ADDENDUM NO. 1

TERRY CARGIL RESERVOIR

LACEY CONTRACT NO. PW 2019-32

SHEET
E-13
59 of 62

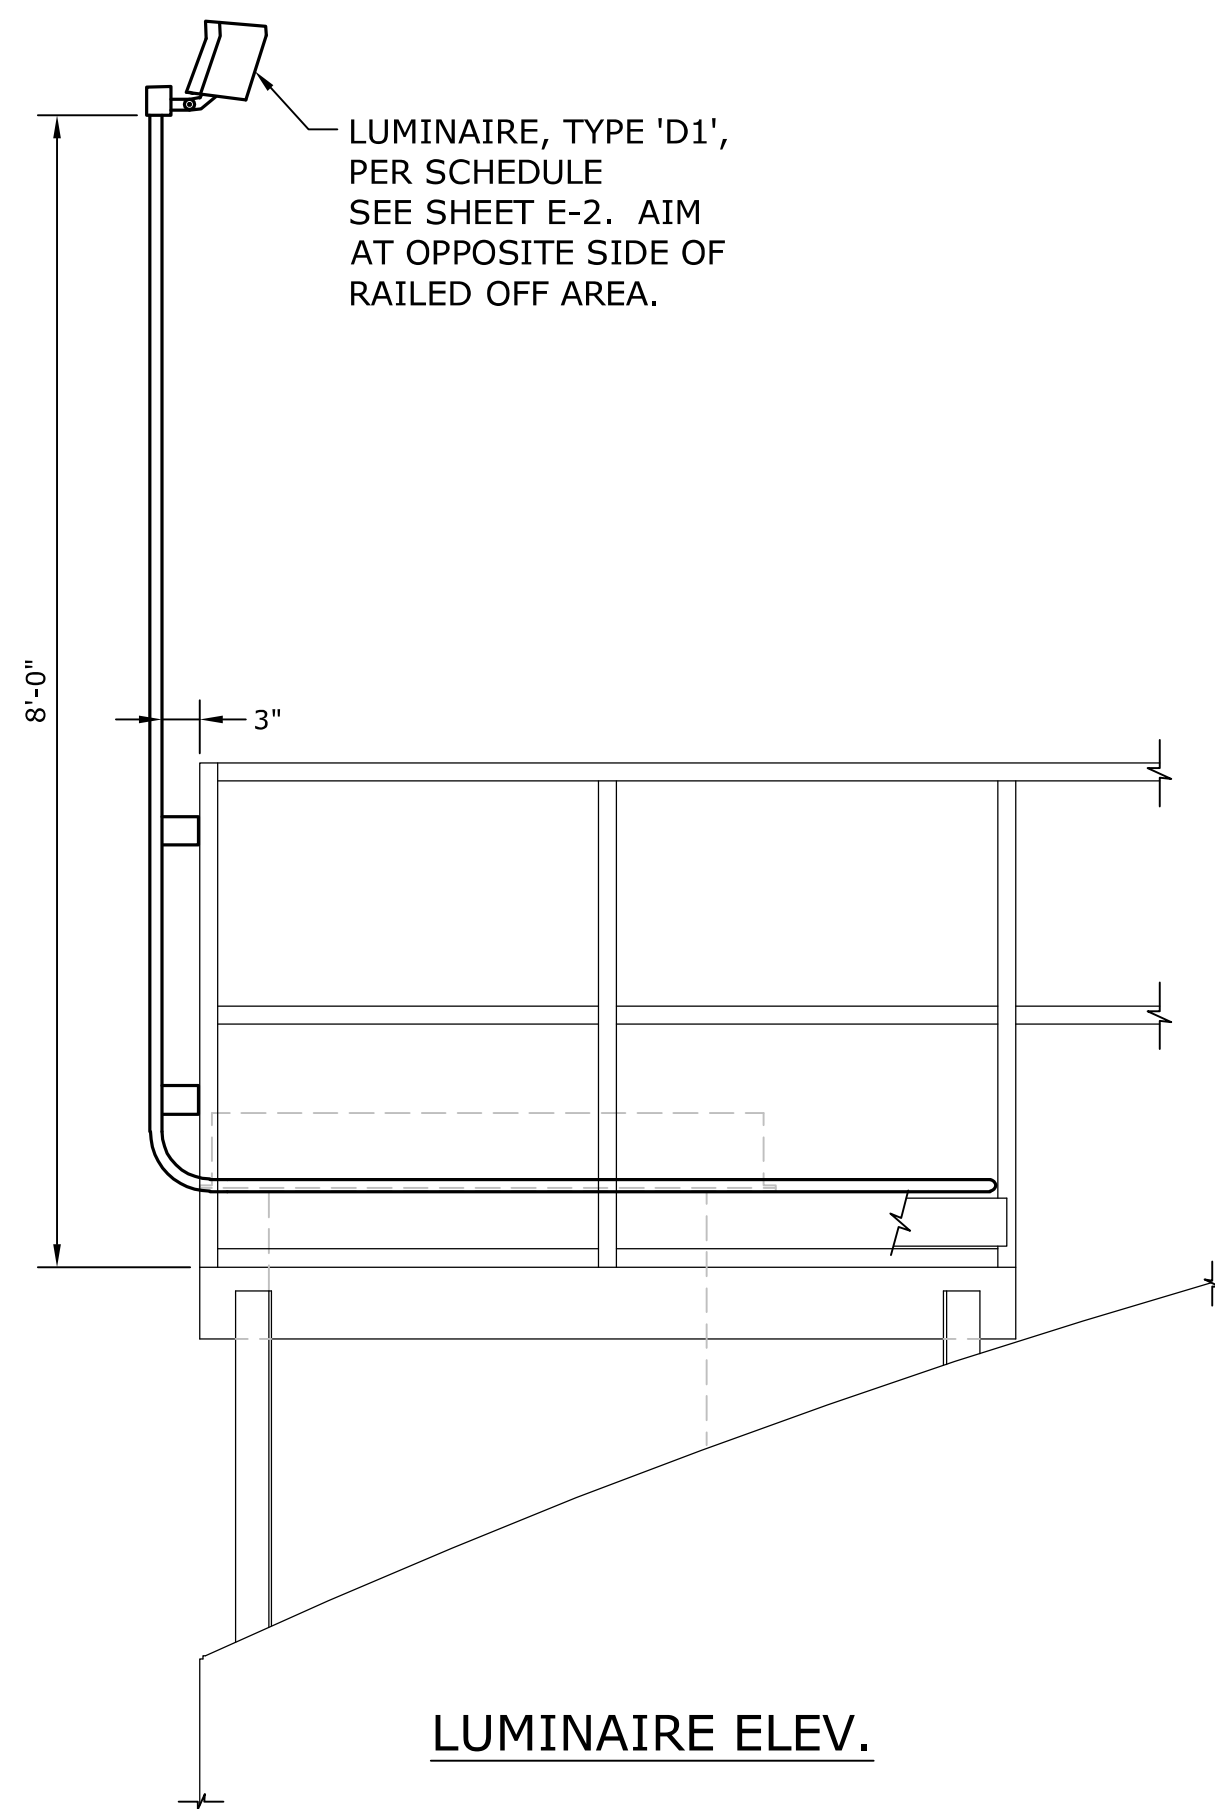
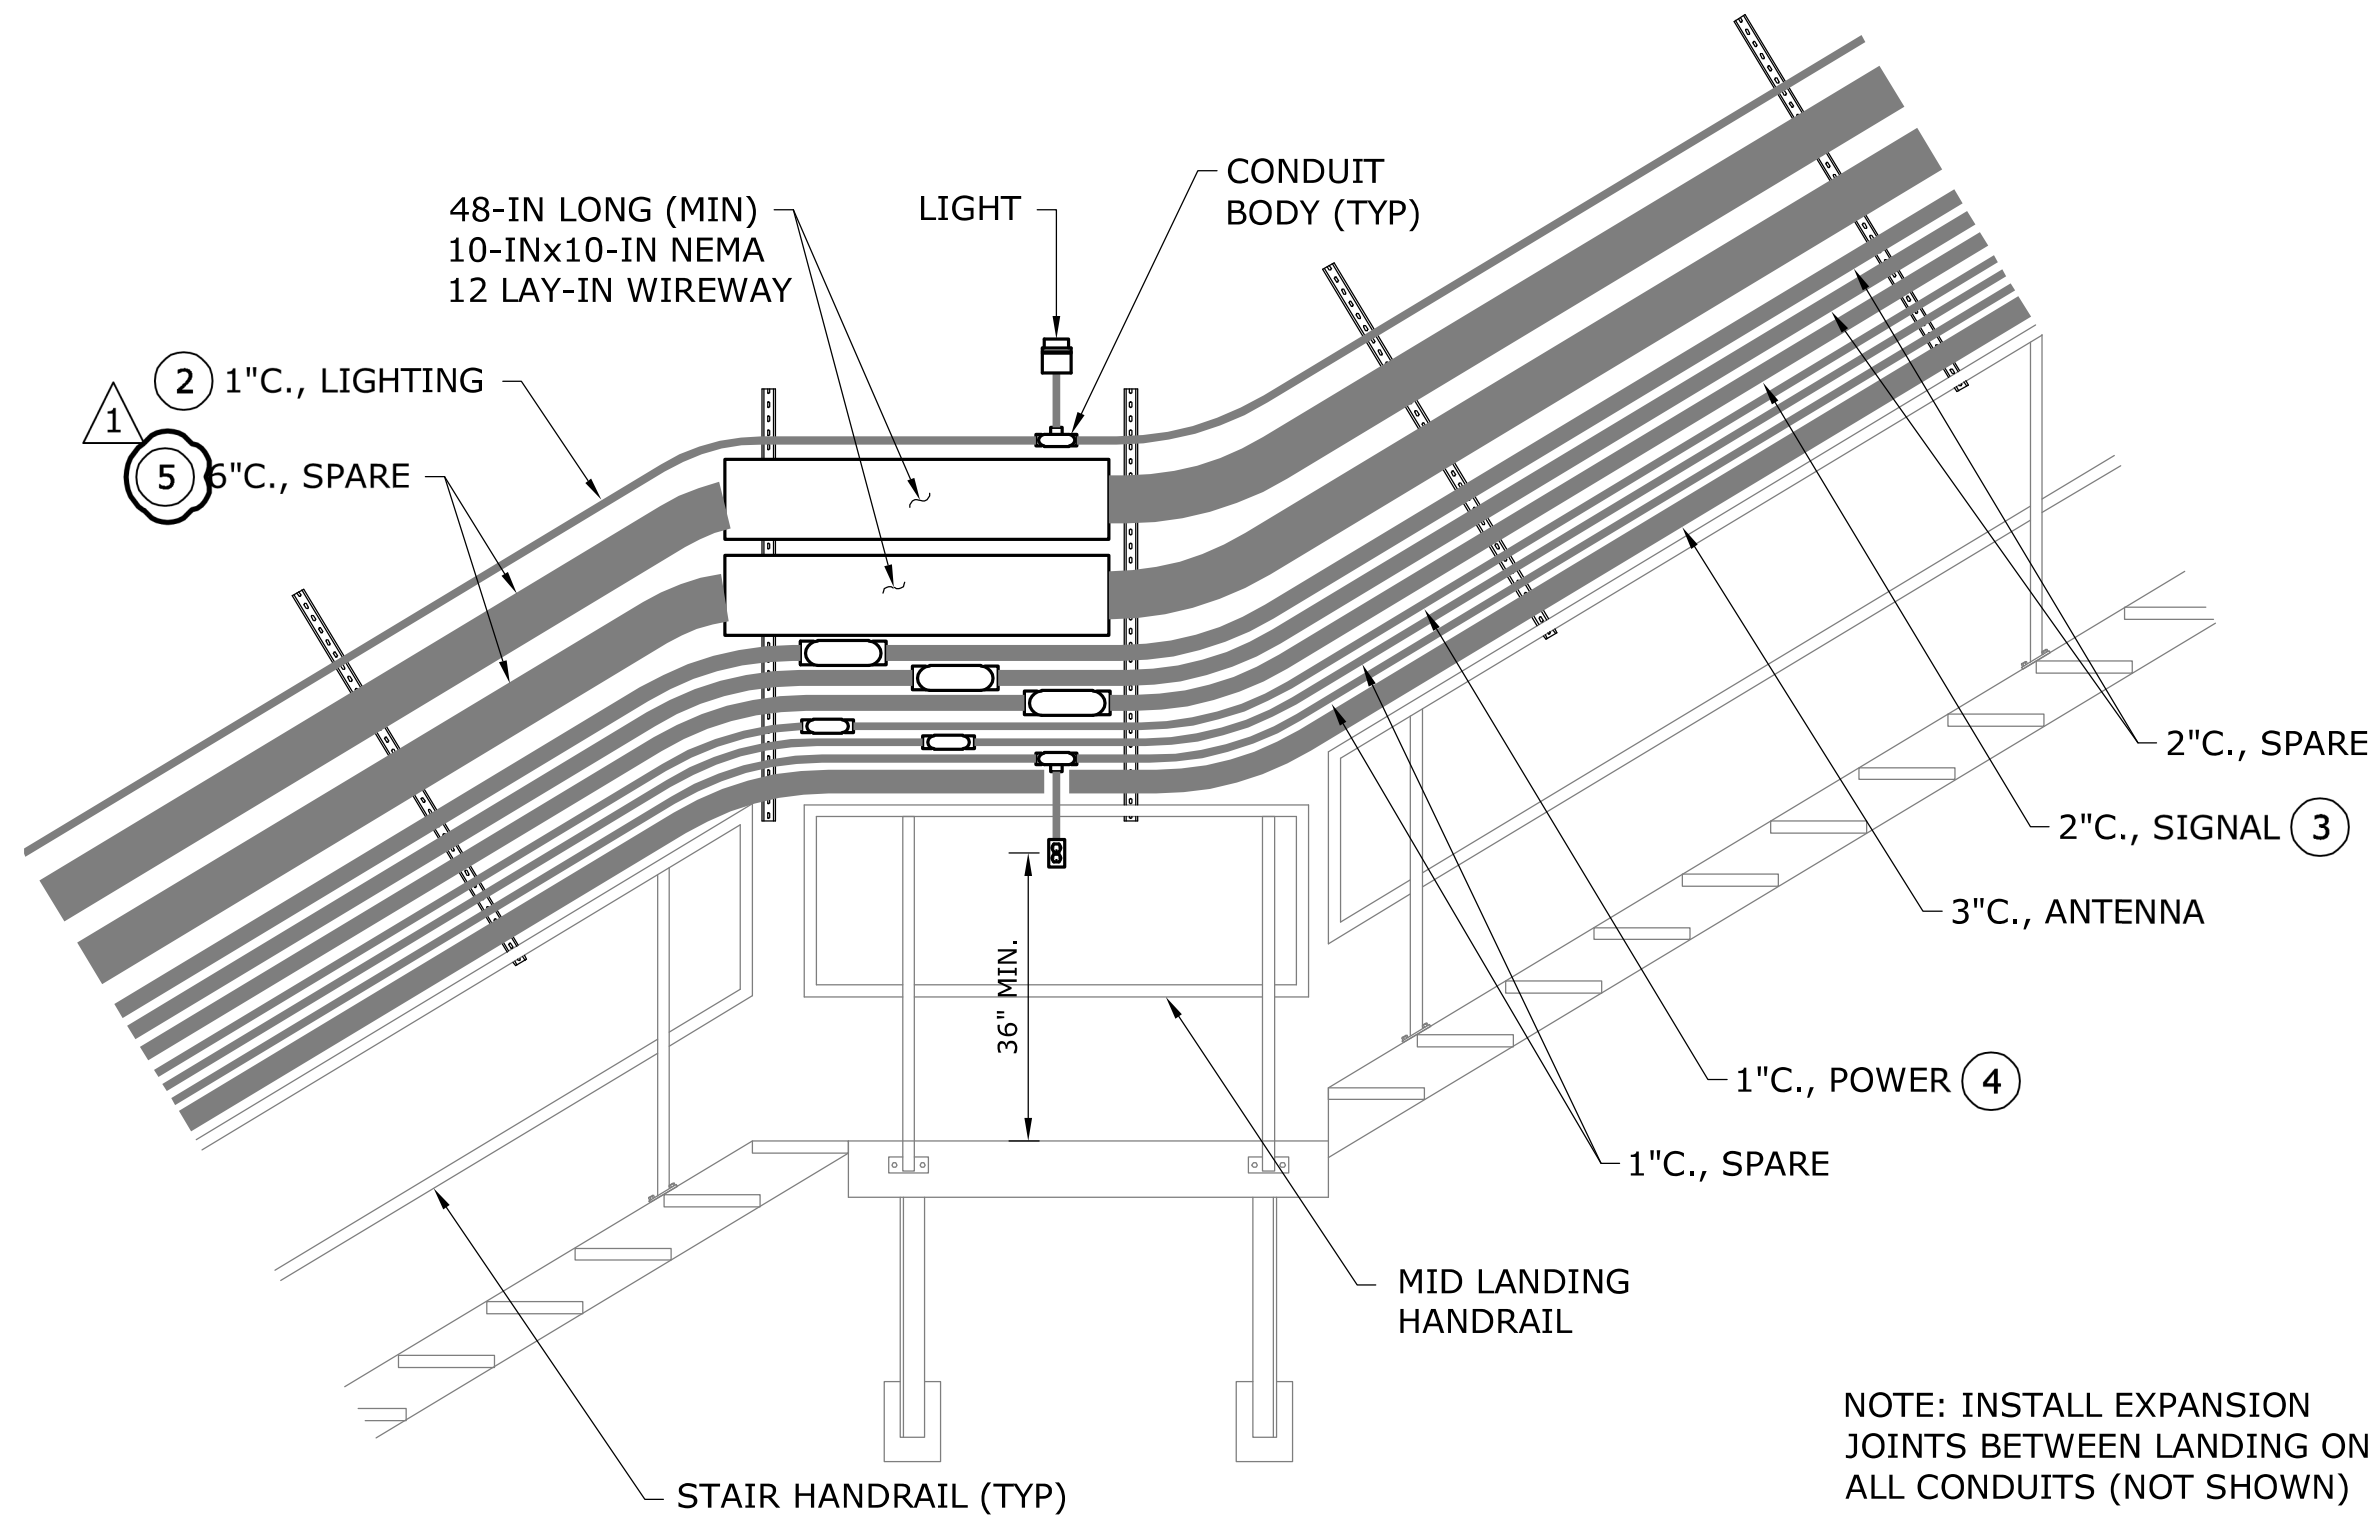
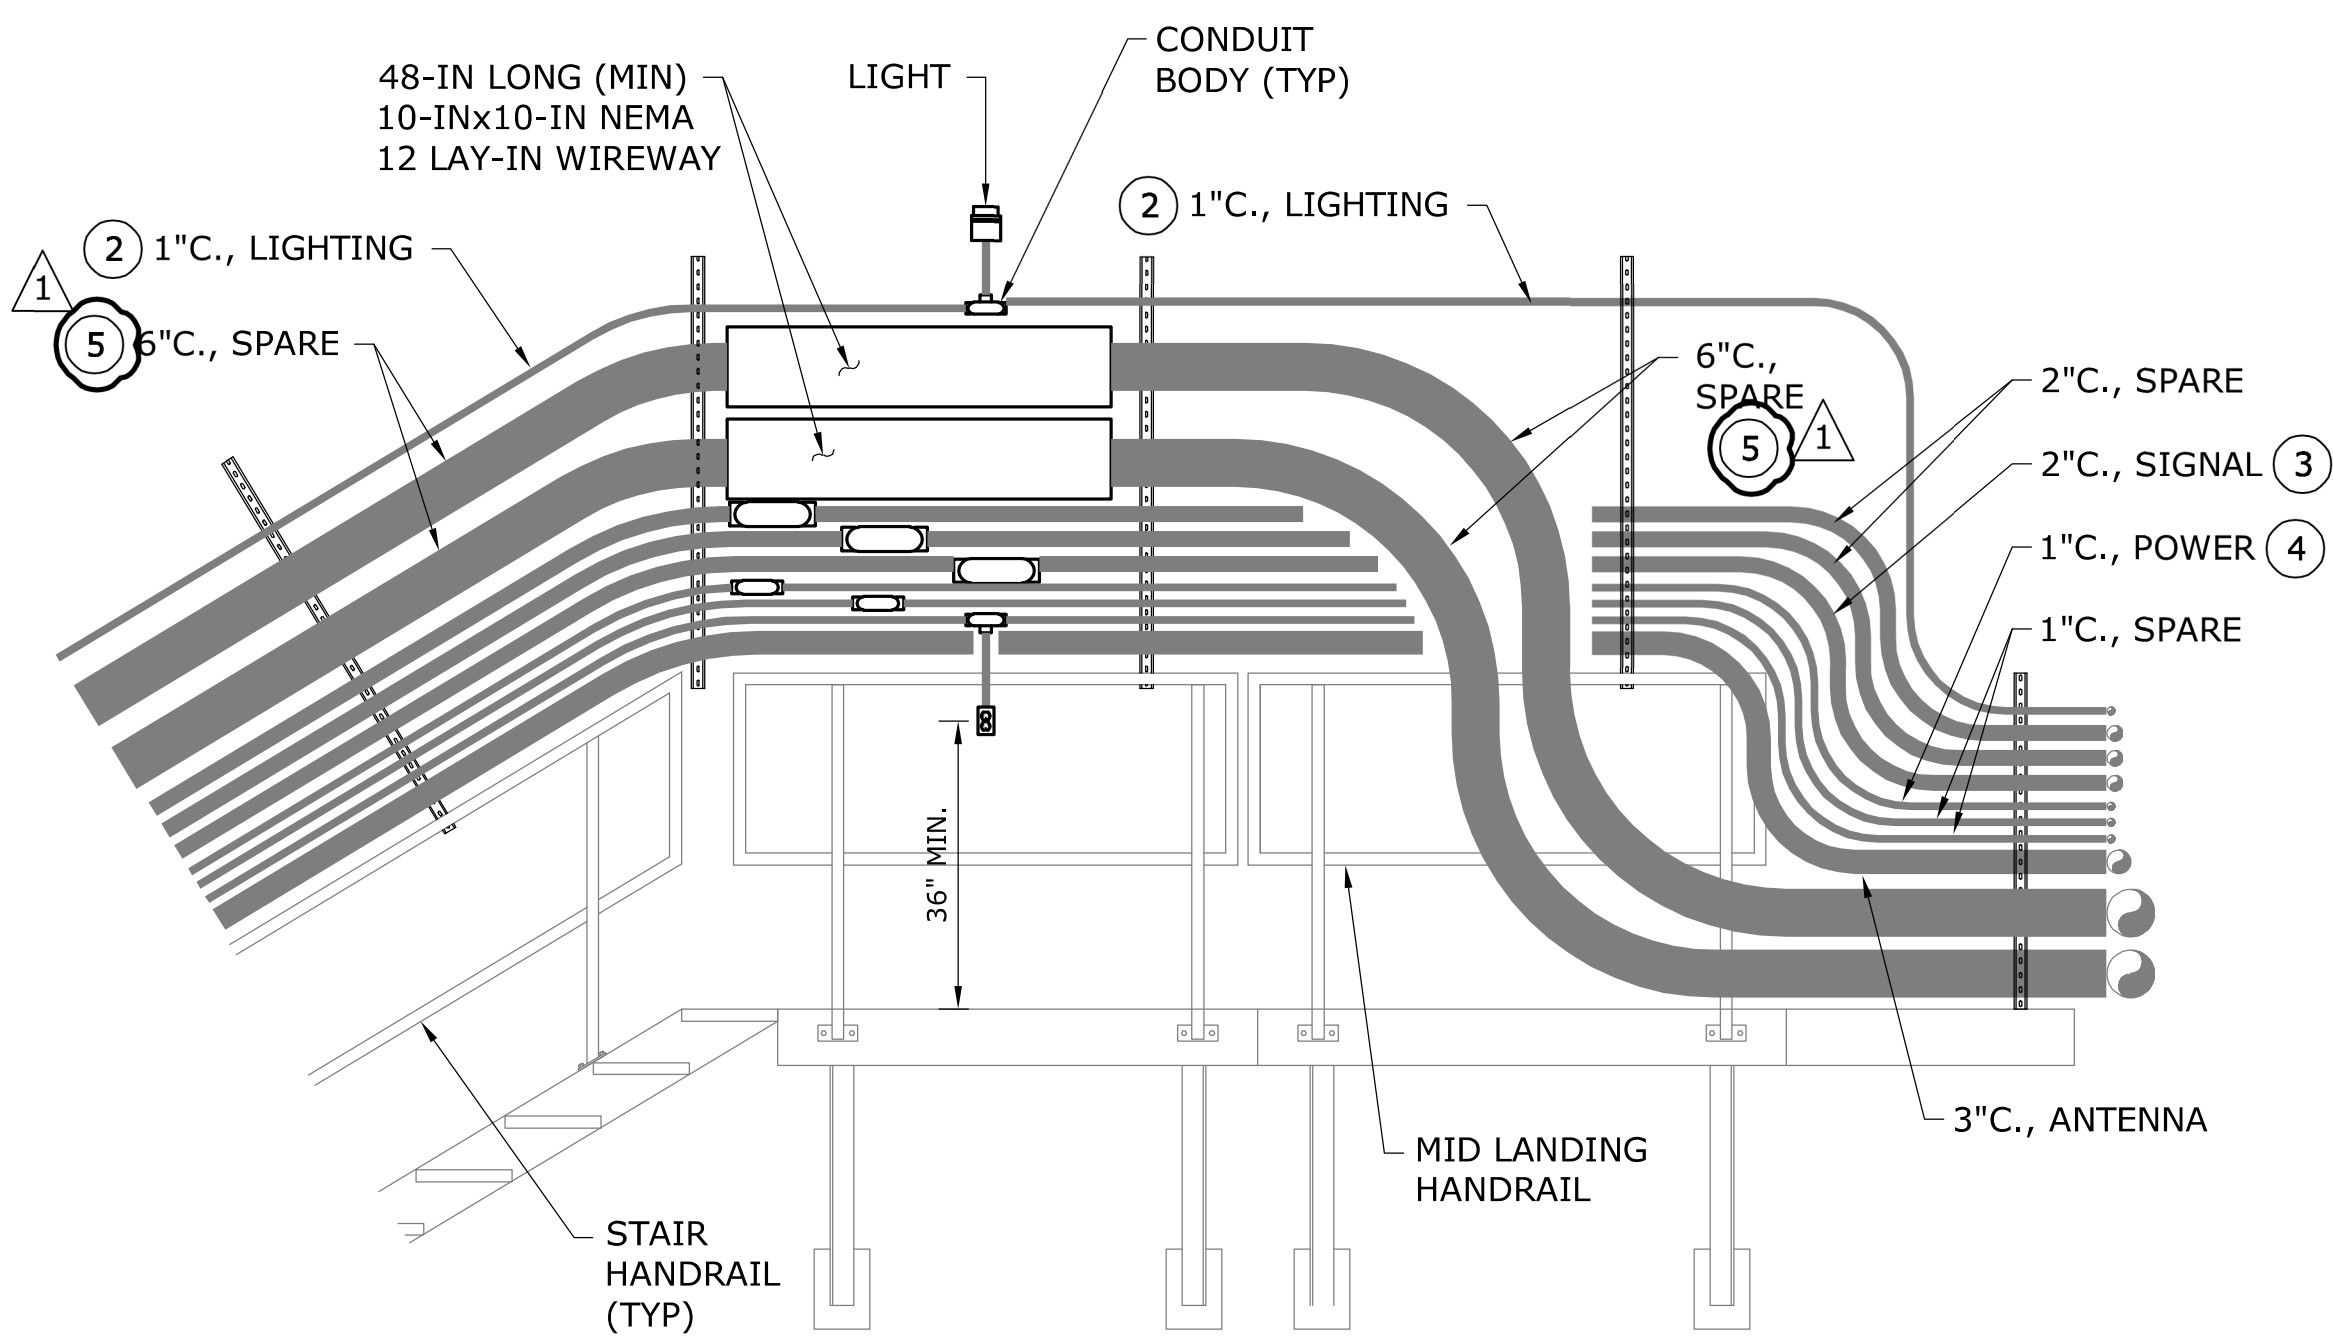
- 1) *The revisions include changes to notes related to the 6-inch diameter spare conduits.*
Delete Sheet E-13 / Page 59 of 62 and replace it with the new page as attached.

5 ALTERNATE OPTION: CONTRACTOR MAY INSTALL (4) 4-IN "SPARE" CONDUITS IN LIEU OF THE (2) 6-IN "SPARE" CONDUITS. MAKE ADJUSTMENTS TO WIREWAYS (PULL BOXES) AS REQUIRED. CONTRACTOR MAY TERMINATE (2) 4-IN "SPARE" CONDUITS PER WIREWAY OR USE (4) INDIVIDUAL WIREWAYS. WIREWAYS (PULL BOXES) TO BE SIZED PER NEC 314.28.
